ROEBUCK
RESIDENTS' ASSOCIATION

Re. Planning Reference D16A/0212
Location: The Grove, Goatstown Road, Dublin 14

We wish to make an observation on the further information submitted on 23rd August 2016. There are two points we would like to address, 1. Pedestrian Access to the Site at Friarsland Avenue, and 2. Child Safety.

Fig.1 - Shortcut route through The Grove. Note the downward incline on the path where it meets the road.

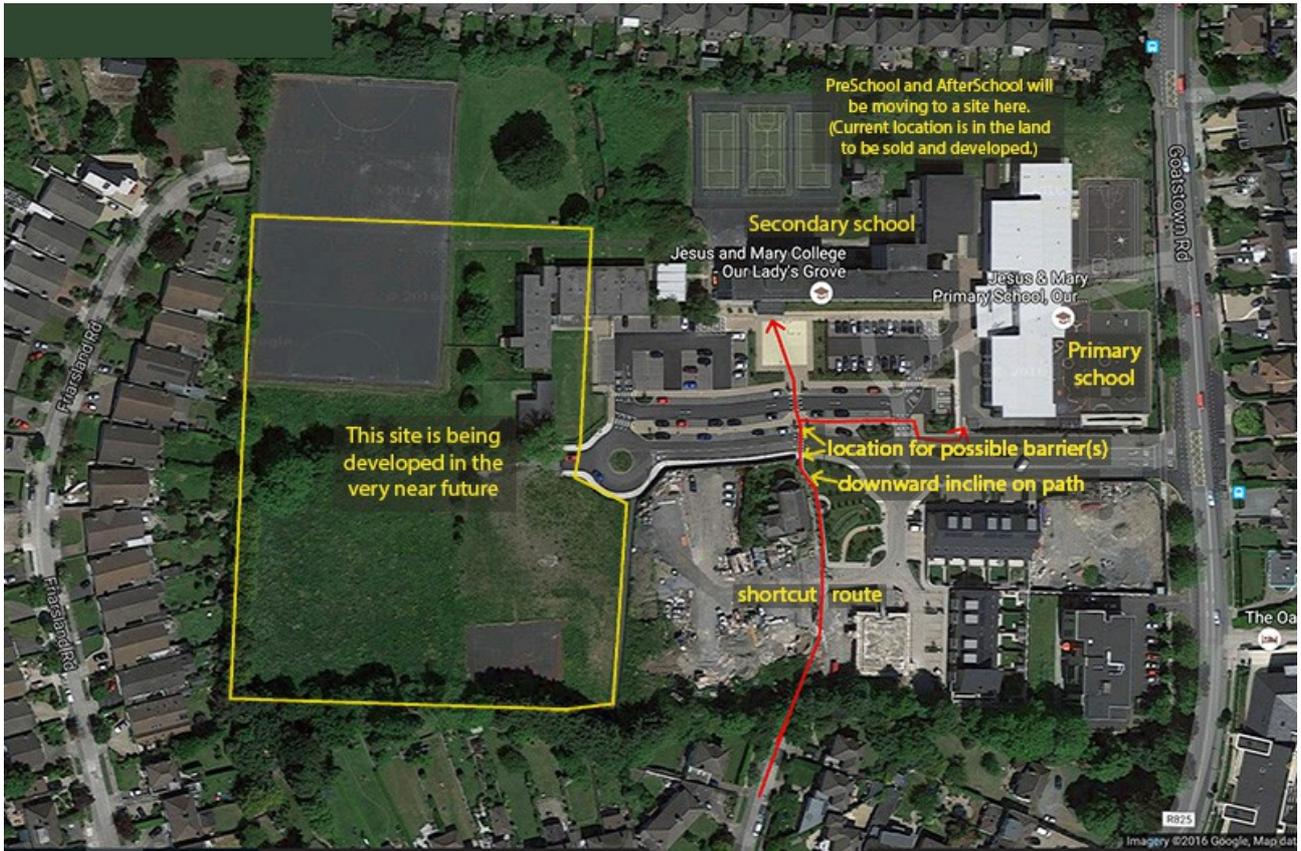
We feel it imperative that, at the very least, a barrier(s) should be erected at the crossing where the path coming from the shortcut through The Grove meets the road. Currently there is a zebra crossing here with no barriers on either side. When the new path coming

through The Grove (in front of the old convent building) is opened it will give children on scooters and bikes plenty of space to build up velocity and come at speed out onto the road. There is a downward incline on this path adding to the danger here (see Fig. 1 below). The risk of an accident will be especially acute during morning drop off times, with residents leaving for work at the same time as parents, children and staff arriving for pre-school and school.

In the original planning permission document Reg. Ref. D11A/0595, section 3.8, we note there is reference made to “*safe pedestrian access for school children*”, and even a mention that a 5kph sign will be erected. Averting the possibility of children scooting or cycling at speed out onto a road is definitely something that would be covered by the term “*safe pedestrian access for school children*”. A barrier at the junction where the path meets the road, at the end of this downward incline, is an absolute necessity.
